MEMO TO: City of Bayonne Zoning Board

RE: 646 JFK LLC
Use & Bulk Zoning Variance Relief
Planning Report # 2
Block 188 Lot 40
646 John F. Kennedy Boulevard
Bayonne, New Jersey
Our File: PBYZ0188.01
Application # Z-22-003

City of Bayonne Zoning Board
Re: 646 JFK LLC (Z-22-003)
Use & Bulk Zoning Variance Relief
Planning Report #1

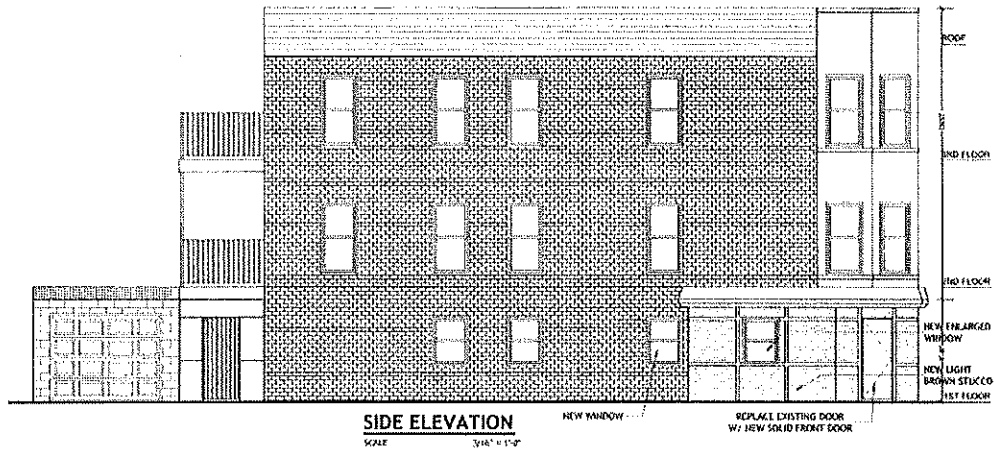
- ii. Applicant should discuss the revised floor plan, especially because the main front door to the first floor unit is opening into the proposed bedroom while living room is at the back. Discuss regarding entrance to the unit and floor layout should be discussed.

Proposed Elevation: Site Plan 09-21-2022

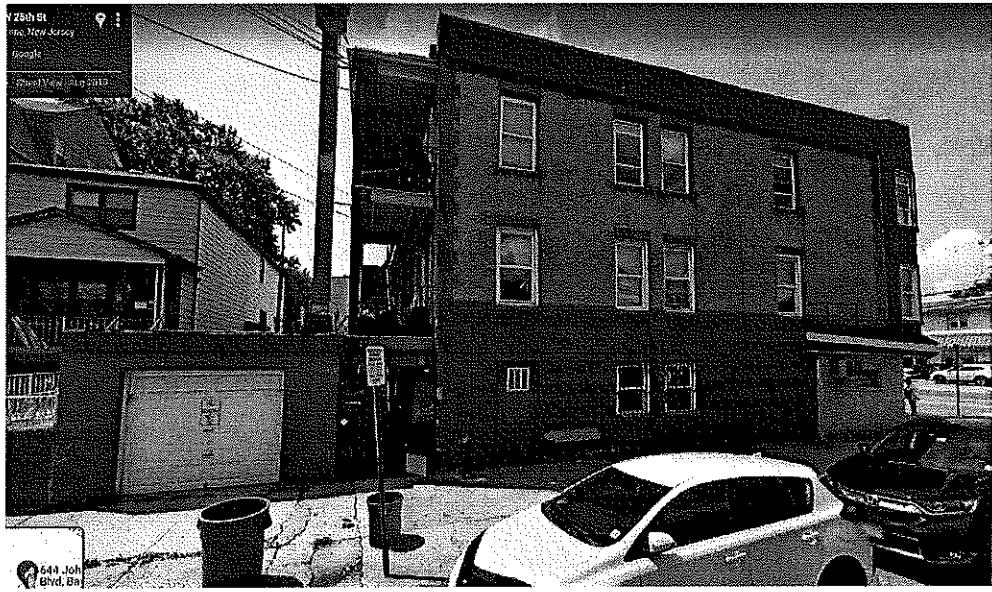
- i. Per §33-10.19 of the City Planning and Development Regulations, "*if ... a first floor commercial use is proposed to be converted to a dwelling unit ... the design features of the storefront architecture shall be preserved to the maximum degree possible. Storefront display windows shall be maintained.*" The Applicant is proposing several alterations to the front of the building where the existing first-floor commercial use is proposed to be converted to two-bedroom unit. These alterations include: two (2) new enlarged windows, and one (1) new door and a new light brown stucco façade in the northeastern corner of the building. While the intent of the ordinance is to promote the appearance of the commercial interactive street, the proposed residential use privacy is to be maintained. Applicant should discuss how this is achieved and the **adequacy of these proposed alterations to the exterior of the first floor of the building as it pertains to §33-10.19 of the City Design Standards.**

- iii. Applicant should discuss in detail regarding the façade improvement. The elevation notes update along the northern corner and front elevation, however applicant should discuss if façade of the entire building is to be updated.
